Product / Process Change Notification

PCN No: PCN-2018-04-09

Change Title: New fixing strap for CA/CM safety caps

Affected Product(s):

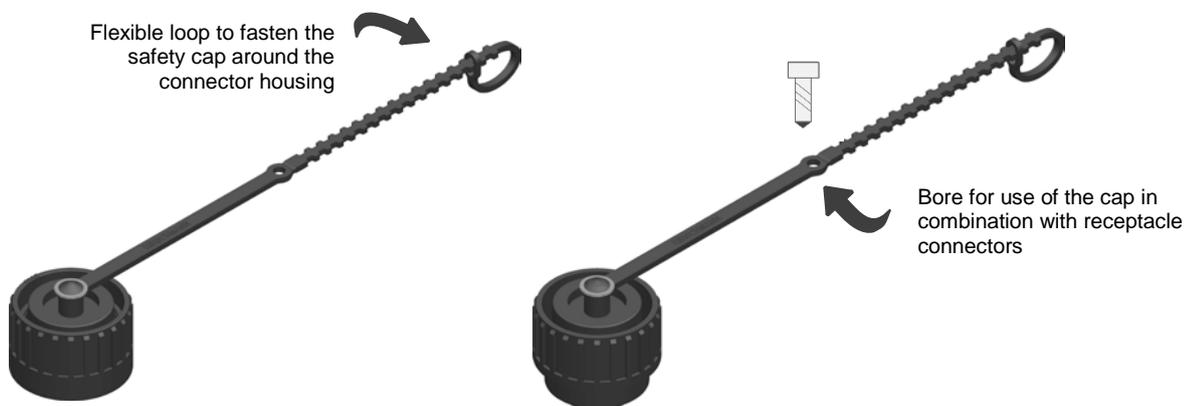
The product change implies the modification of the fixing string used to securely fasten the dust caps in an unmounted condition. In the course of the product change the so far used perlon string will be replaced by an elastic plastic band being improved regarding tensile stress, handling and appearance.

The highly flexible fixing strap is designed in a way it can be used with both field-attachable and receptacle connectors. If the safety cap is used in combination with a field-attachable connector, the variable loop comes into action with which the cap is attached to the connector housing.

If the cap shall in contrary be fastened with the aid of a screw, the borehole on the strap can be used. In that case the variable loop is not needed. The marking on the band indicatives where it can be cut off.
